SUBJECT: Partial Supplement to Plate #12

DATE: November 18, 1931

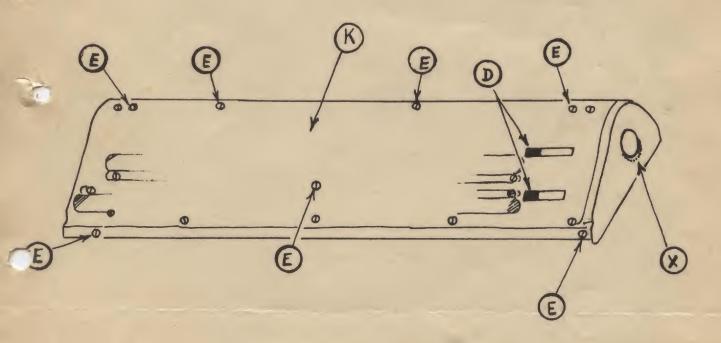
When it is necessary to remove the front carriage cover case complete as illustrated and explained on Plate 12, Figure 2, Operation 81, Machine Service Bulletin 116, elongate slots D to the left 1/16 of an inch by filing with Kit Tool #21.

Remove screws E as shown on the revised illustration below. This eliminates removing all screws identified as E as shown on the original Plate 12, Figure 2, Operation 81, for the purpose of removing the front carriage cover case.

Before reassembling cover case K enlarge the lower half of the clearance hole for the clearout handle shaft 1/32 of an inch by filing as shown by dotted line K. This eliminates a possible interference at this point when removing or reassembling the complete case.

As this change is incorporated in all recently manufactured machines do not file slots D or enlarge hole X until it is ascertained whether the cover case can be removed and reassembled as explained in this bulletin.
